## GOVERNMENT/INDUSTRY AERONAUTICAL CHARTING FORUM Instrument Procedures Group October 17, 2006 HISTORY RECORD

## FAA Control # <u>06-02-265</u>

Subject: Retention or Development of Lowest Possible RNAV LNAV and/or VNAV Minimums.

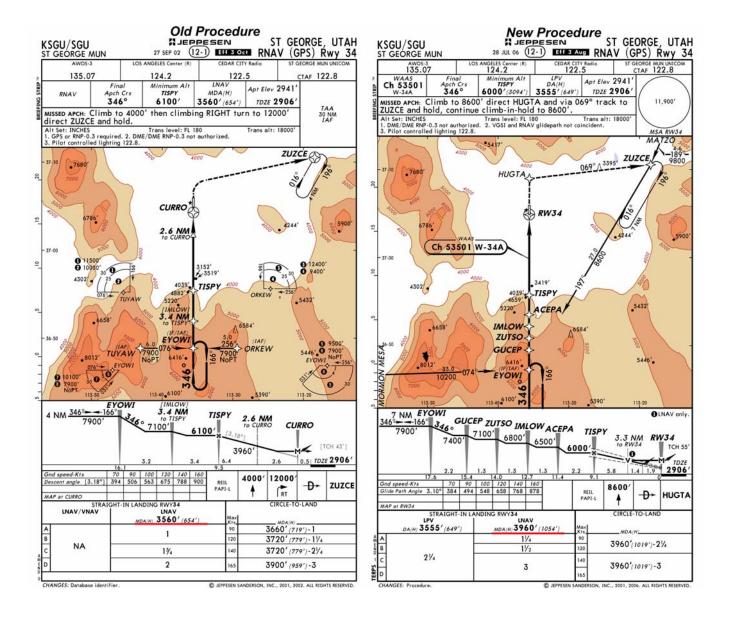
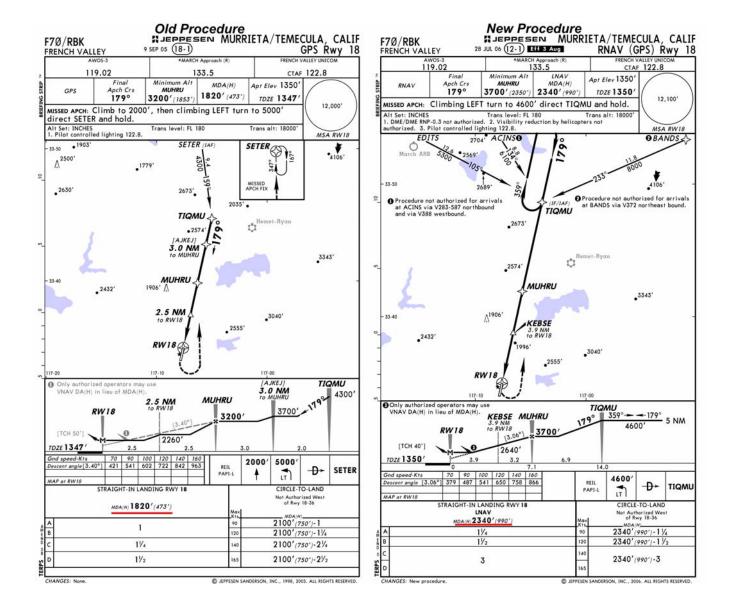
**Background/Discussion:** As the NFPO implements the LPV program, a conflict in LPV and LNAV/VNAV criteria has resulted in substantial increase in LNAV and/or VNAV minimums. This is the result of either lowering an existing LNAV IAP's final segment slope to accommodate LPV glide-slope requirements (the shallower angle causing the loss of a significant LNAV step-down fix) or the very restrictive LPV missed approach criteria causes an LNAV missed approach penetration at a mountainous location that formerly did not exist using LNAV missed approach criteria. An example of this is at St. George, Utah, RNAV Runway 34 (attached, old and new IAPs). Note the 400' increase in LNAV minimums on the new procedure.

Another example is French Valley (attached, old and new IAPs). Note the 517' increase in LNAV minimums. Note also no LPV procedure was added. The procedure was redesigned to add LPV minimums, but obstacles in the missed approach area precluded the LPV procedure. However, the upwards adjustment of LNAV minimums was left in place, which serves greatly to the detriment of the users of this airport. Note also the new terminal routing in the new F70 procedure, none of which are "NoPT" even though fundamental TERPS concepts dictate NoPT on two, if not all three of these terminal routes. (NBAA has had policy discussions with AFS-420 about application of NoPT in such circumstances.)

**MEETING 07-01:..** Brad Rush, AJW-321, briefed that the RNAV approach at French Valley, CA (F70) is under amendment to lower the LNAV MDA. The RNAV approach at St. George, UT (SGU) requires the initial portion of the missed approach be straight to accommodate LPV and Air Traffic wants the same track for the LNAV approach. Brad further stated that the NFPO has approximately 6-8 airports where 2 RNAV approaches were published to retain the lowest minimums for both LNAV and LNAV/VNAV and LPV. NFPO personnel are trained to develop separate approaches when necessary to preclude high LNAV minimums. Wally Roberts, NBAA, asked how a user can find out about air traffic decisions for restrictions on approaches. Brad recommended contacting the applicable ATO Service Area FPO. Bill Hammett, AFS-420 (ISI) briefed that current policy requires that the minimum step-down altitude be at or below the descent path on procedures that provide both vertically guided (LNAV/VNAV and/or LPV) and non-vertically guided (LNAV and/or LP) minimums. Jack Corman, the AFS-420 RNAV criteria writer, is studying this requirement and the feasibility deleting the requirement for the non-vertically guided procedure to provide a stabilized descent from the (P)FAF to TCH. If this were the case, F70 LNAV minimums would still be the lower value even if the LPV were published. Brad advised that if new policy is under consideration, it should include exact criteria when a separate procedure is required. ACTION: AJW-321 and AFS-420.

MEETING 07-02: Brad Rush, AJW-321, briefed that the amendment for the RNAV approach at French Valley, CA (F70) will be effective on October 25<sup>th</sup>. Brad also briefed that the NFPO has established internal operating procedures that should clarify the intended objective and assist procedure developers in repeating situations like those described in the original NBAA recommendation. Additionally, this issue has been made a "special interest" item for QC. Tom Schneider, AFS-420, stated that the NFPO internal guidance makes an Order 8260.19 policy change unnecessary and recommended the issue be closed. The group agreed. Item Closed.
